**STATE OF TENNESSEE  
DEPARTMENT OF TRANSPORTATION  
DESIGN DIVISION**

**INSTRUCTIONAL BULLETIN NO. 13-25**

**Regarding Revised Standard Drawings**

**Effective for the April 2014 Letting (January 22 turn-in) , the following Standard Drawings are revised and Section V of the Design Guidelines is revised for this update.**

DESIGN STANDARDS  
1 & 2 LANE  
RAMPS

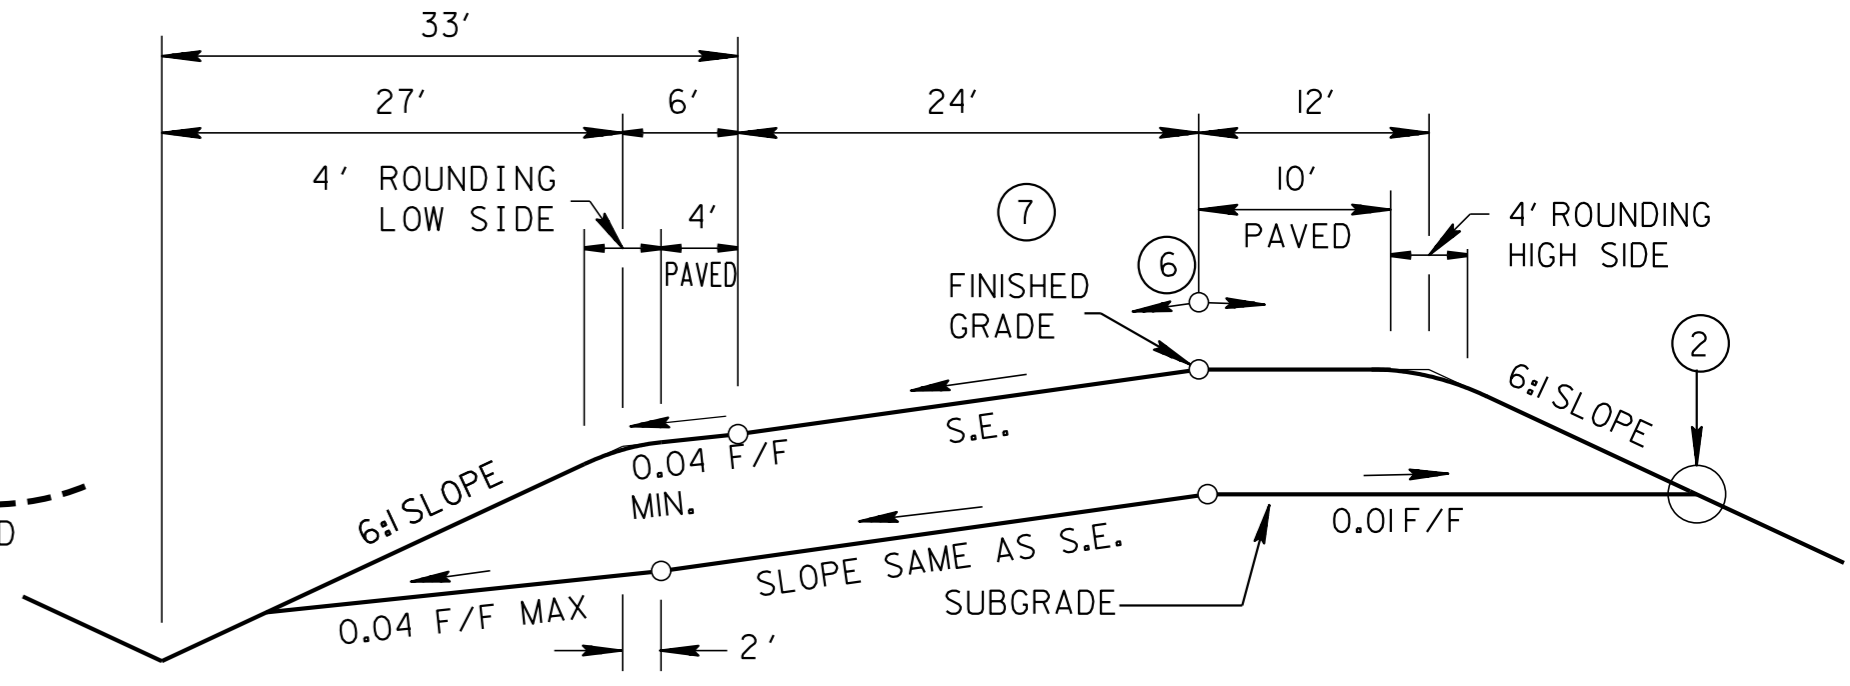
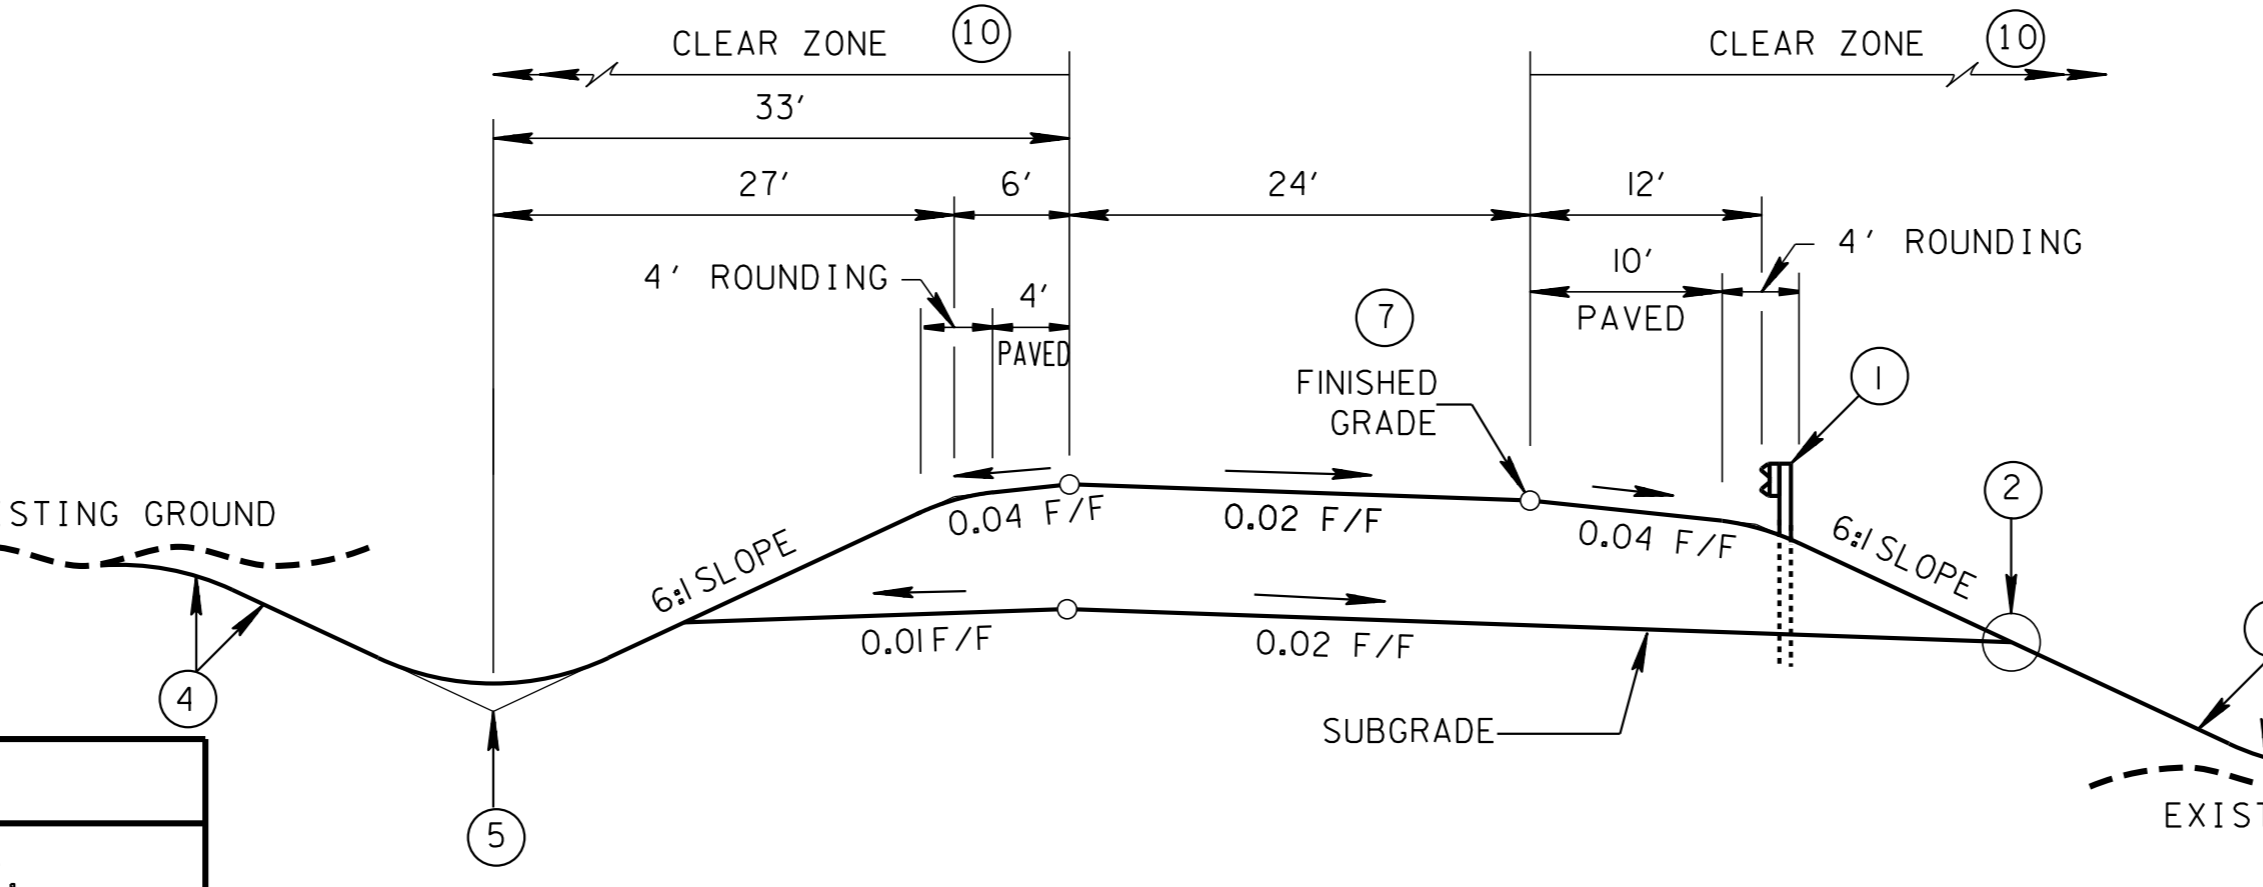
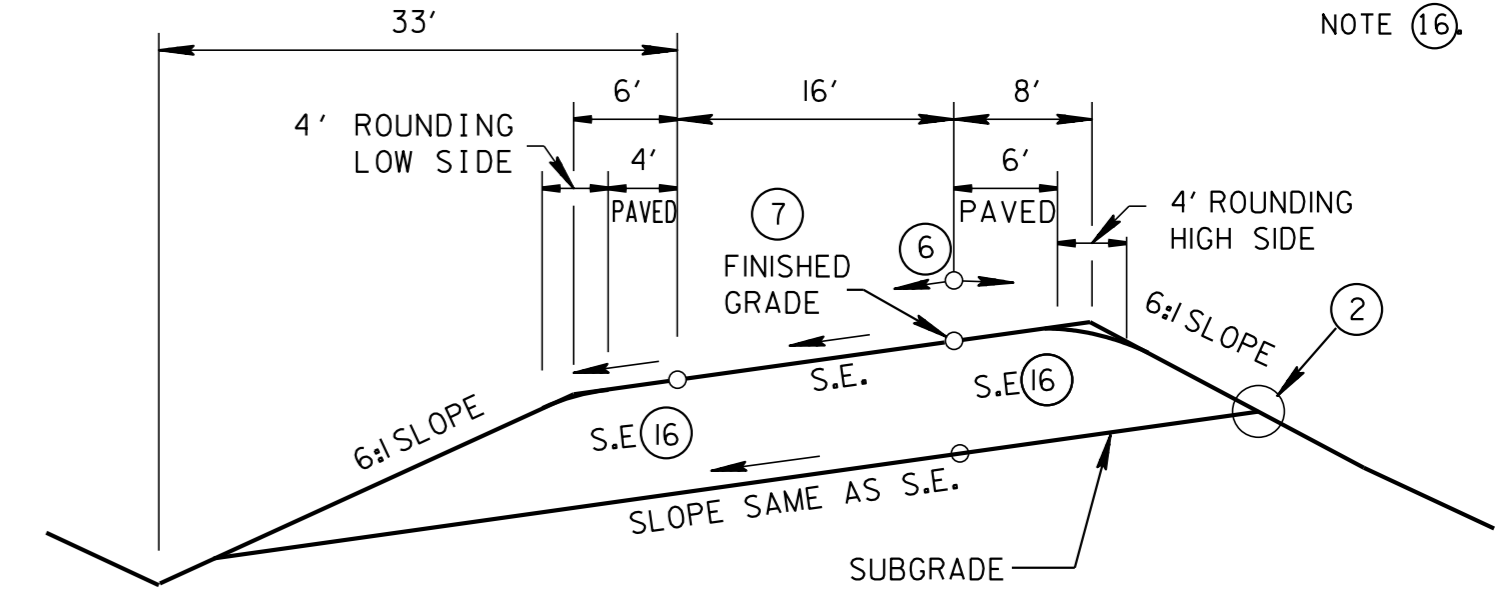
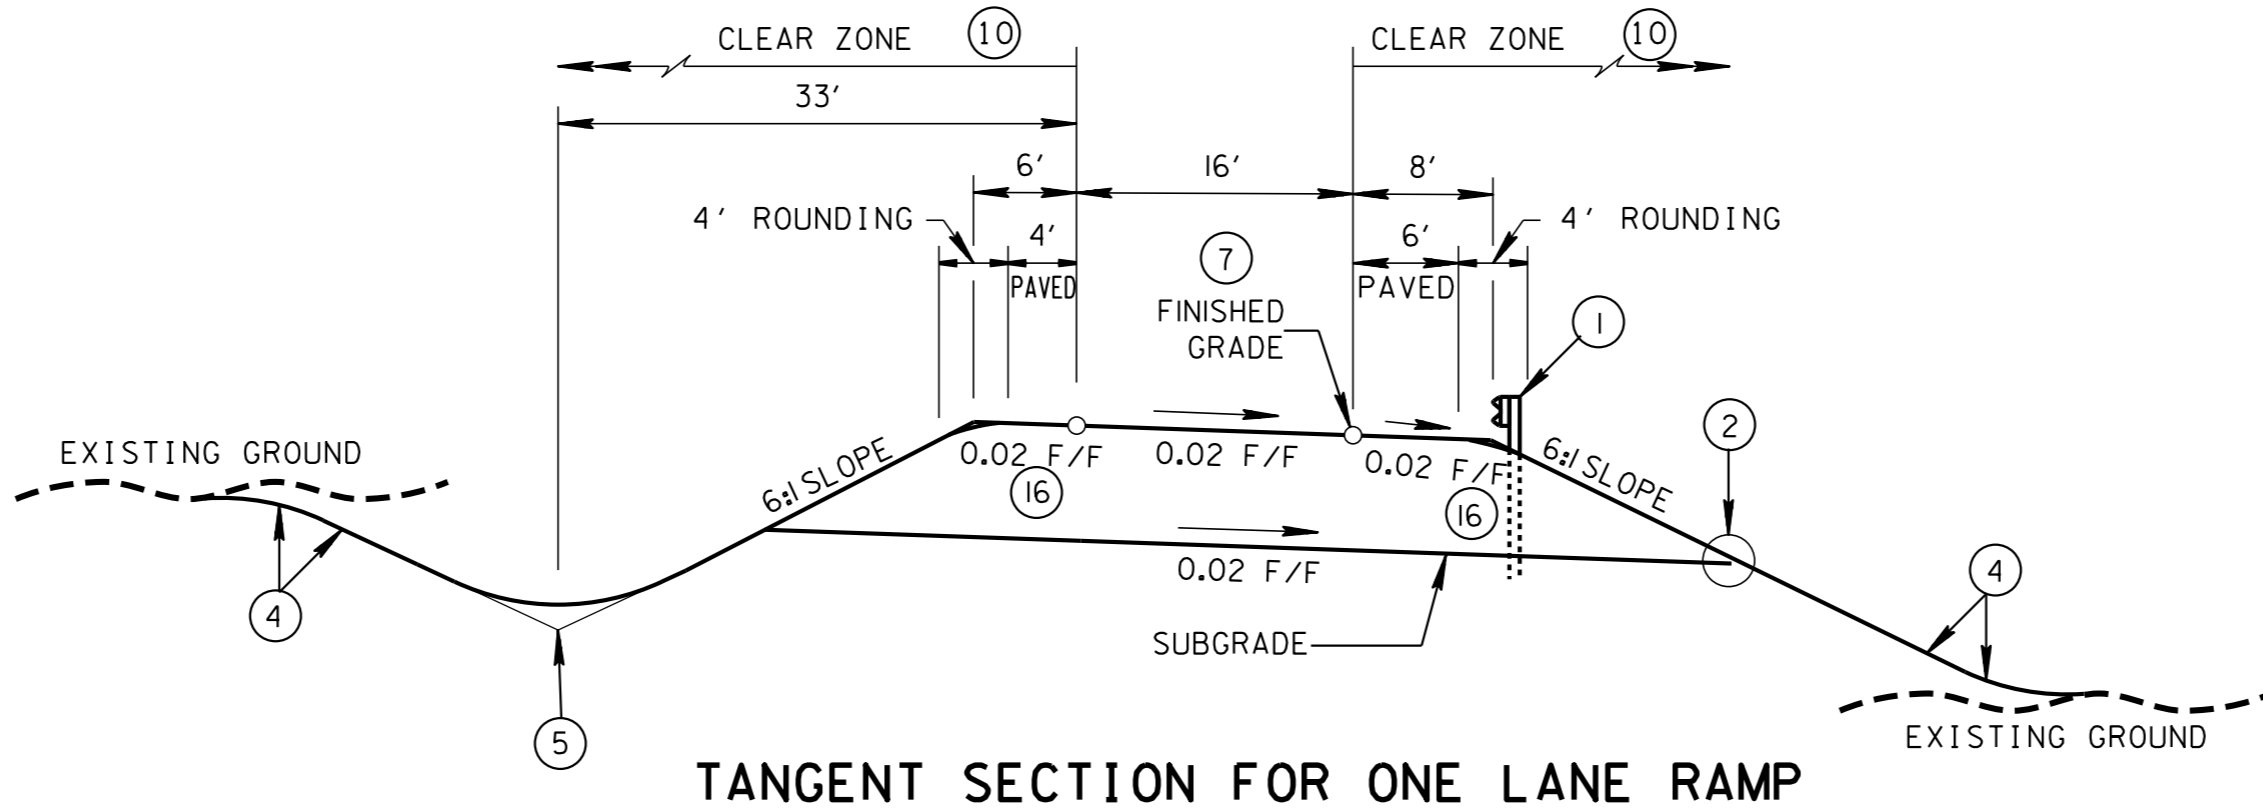
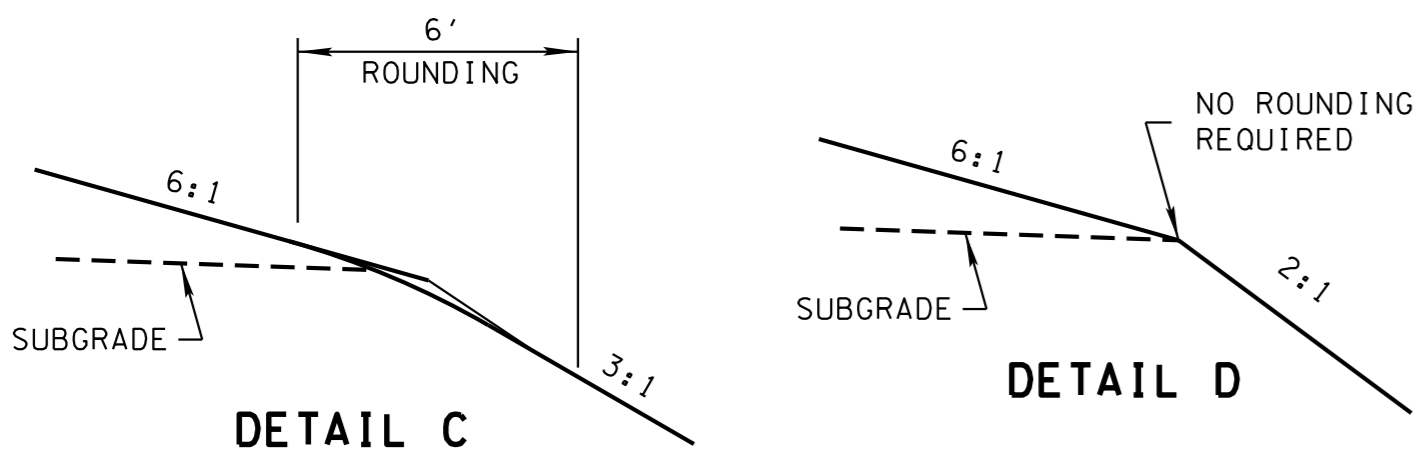
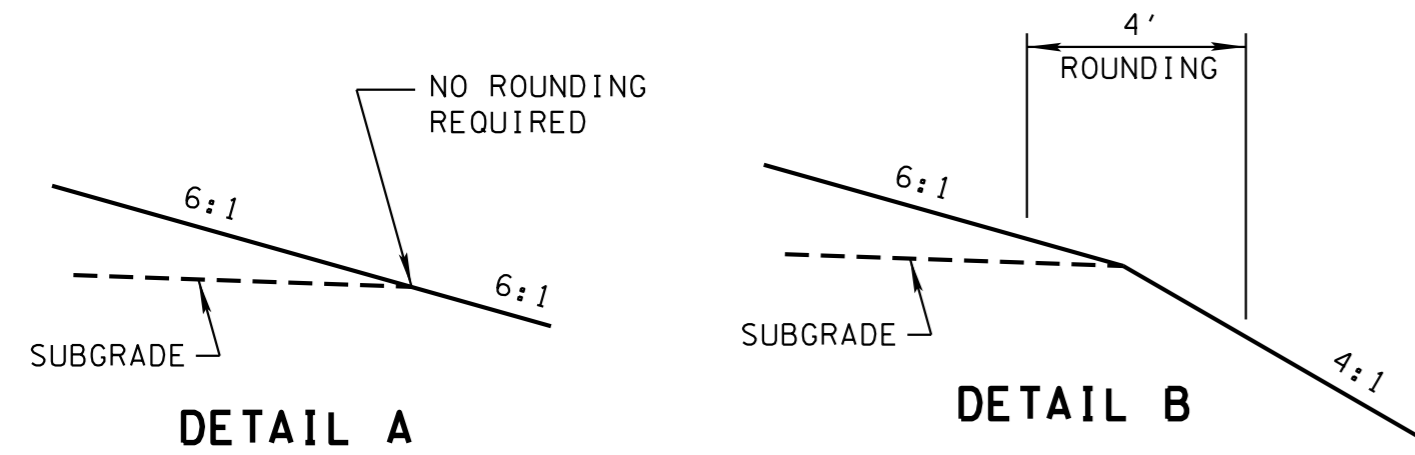
REV. 07-23-13: CHANGED SHOULDERS TO CONSTANT SLOPE FOR ONE LANE RAMPS ADDED NOTE (16)

- (14) FOR DESIGN SPEEDS GREATER THAN 45 MILES PER HOUR, USE VALUES FOR OPEN HIGHWAY CONDITIONS.
- (15) SUPERELEVATION ASSUMED OF 8%.
- (16) FOR CONCRETE RAMPS USE CONSTANT CROSS SLOPE FOR LANES AND SHOULDERS, FOR ASPHALT RAMPS USE .04 F/F FOR TANGENT SHOULDERS AND A CROSS SLOPE FOR SHOULDERS ON THE HIGH SIDE OF SUPER ELEVATION SUCH THAT THE ALGEBRAIC DIFFERENCE BETWEEN CROSS SLOPE DOES NOT EXCEED 7%, THE CROSS SLOPE ON THE LOW SIDE SHALL BE THE MINIMUM OF 4% OR THE SUPER ELEVATION RATE.
